IMPORTANT SAFETY RECALL

NHTSA Recall No. 26V-006

Terex Utilities	
SAFETY NOTICE	SN735

SUBJECT: Upper Control Valve – Enable Cavity Plugs

- Figure 1 - Typical location to inspect of upper control valve enable section

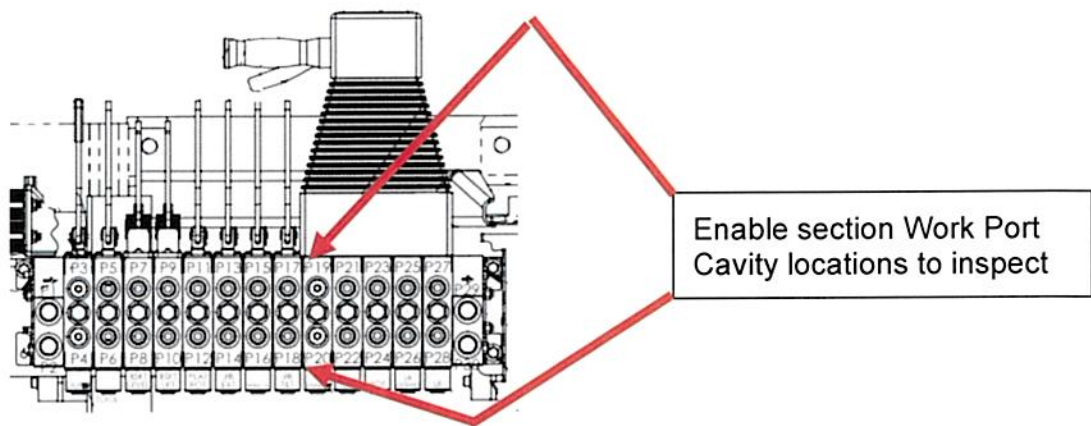
Valve assemblies 462052, 481326, 485616, and 486437 may have been assembled with No Relief (NR) plug in the enable section of the upper control valve for units built from January 1, 2025 to September 9, 2025. The plug in the enable section work port cavity should be a standard SAE O-ring plug to allow oil flow into the return passage when the enable is not engaged. The NR plugs will cause flow across the lower relief valve if upper controls are selected and the enable functions are not operated. It will also hold the engine speed on high throttle if demand throttle is installed. **Continued use will increase the oil temperature and may cause burns.**

There are three methods to determine if a unit is subject to this recall. If in doubt use method 2 to determine if the correct plug is installed in the enable section work port cavities or if Z1765 is required. Position the platform and rotate the platform out if needed, and remove covers if necessary to see the upper control valve as shown in Figure 1.

1. The quickest is to position the platform where you can look at the upper control valve. If the enable section work port cavities have black painted plugs this bulletin applies. If the plugs are silver this bulletin does not apply. Verify by test #3 below.

2. Position the platform where you can look at the upper control valve. Shut off the engine and relieve the pressure by depressing the STOP control at the platform. Position a pan or rags to collect oil spillage and remove the upper and lower work port cavity plugs from the enable section using a 5/16 Allen-Wrench as pointed out in figure 1. If the plug is an NR plug as shown in figure 3 replace with standard plugs as shown in figure 2.

Perform one or more of the inspections above. Refer to the pictures below for clarification. If the plug are black in color or verified by visual examination the incorrect plug is installed and must be removed and replaced with a standard SAE 10 Hollow Hex Plug, 411585 included in Z1765. Fill in the completion record included with the owner letter and return.

Figure 2 – Correct Plug in the enable section cavity locations as shown above.

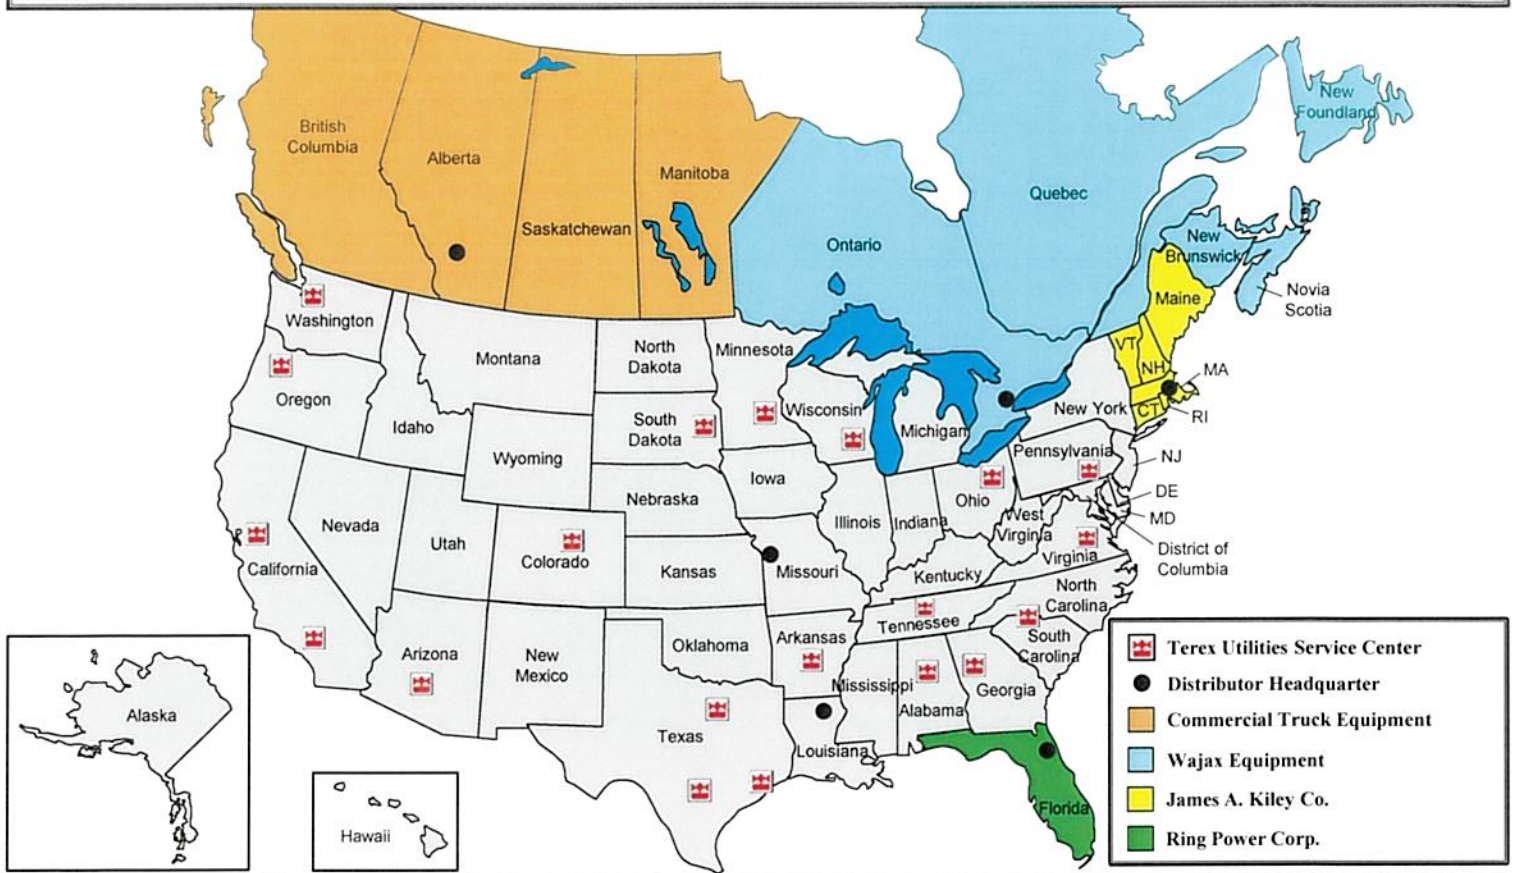
No Relief Plug 446951 (NR Plug) – Exterior paint is black and color under paint is silver

Figure 3 - NR Plug graphics which should not be in the enable section work port cavities.

08MB Hollow Hex plug 411585 Color is silver
